Date 4/22/2025	Bulletin # 127	Model GT1175
Subject Changes to NABCO GT1175 Automatic Sliding Door Carrier for Sliding Panels

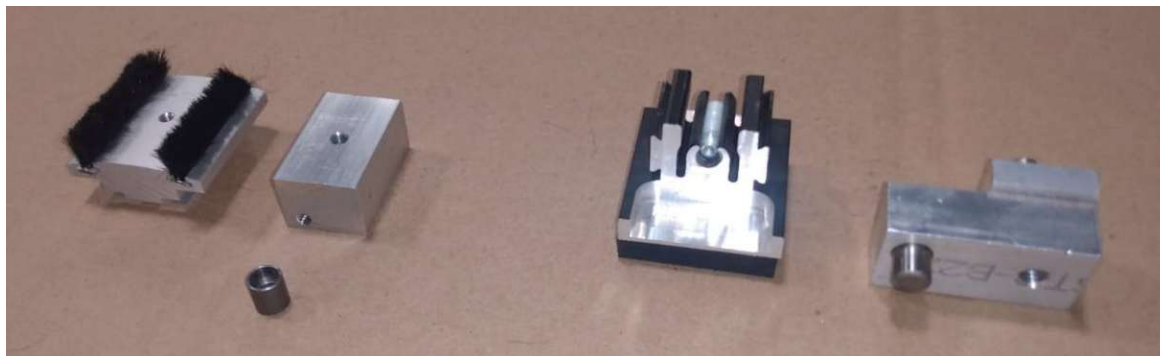
- 2) The end cap on the strike end on single doors has been changed to eliminate interference with the header's end plate.

Old Single Door Strike
End Cap: A-X0133

New Single Door Strike
End Cap: A-00301
